JRPP No:	2010SYE031
DA No:	2010/0257/1
PROPOSED DEVELOPMENT:	Demolition of 3 existing buildings & ancillary structures, the erection of a 23 unit RFB, a child care centre, 43 carspaces & consolidation of lots
APPLICANT:	Greek Orthodox Parish Of St George
REPORT BY:	Eleanor Smith, Senior Assessment Officer, Woollahra Municipal Council

Assessment Report and Recommendation

ITEM No.	R3
FILE No.	DA 257/2010/1
PROPERTY DETAILS	88-96 Newcastle Street, Rose Bay
	Lot & DP No.: LOTS: 14, 15, and 16 SEC: D DP: 5092 LOT: 1 SEC: DP: 92579 LOT: 1 SEC: DP: 1079086 Side of Street: East Site Area (m²): 3470.7m ² Zoning: Residential 2(b)
PROPOSAL:	The demolition of 88 Newcastle Street (dwelling), 94 Newcastle Street (dwelling), 96-98 Newcastle Street (St Paul's Anglican Church and former Parish Hall) and the construction of a new residential flat building, a new childcare centre, and the retention of the existing Greek Orthodox Church of the Parish of St George.
TYPE OF CONSENT:	Integrated - RTA
APPLICANT:	Beraldo Design Pty Ltd
OWNER:	Greek Orthodox Parish Of St George
DATE LODGED:	02/06/2010
AUTHOR:	Ms E Smith
CONSENT AUTHORITY	Joint Regional Planning Panel (Regional Panel)

Magnified view from across the front boundary from the northern side balcony to the living room

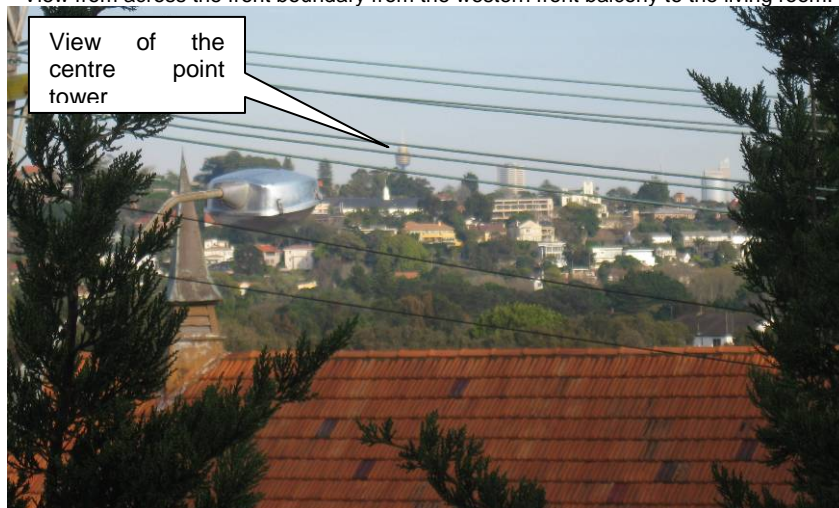
The proposal will remove the views of the Harbour Bridge and North Sydney. Given that the proposal will remove the only iconic views to unit 2 the view loss is considered to be moderate-severe.
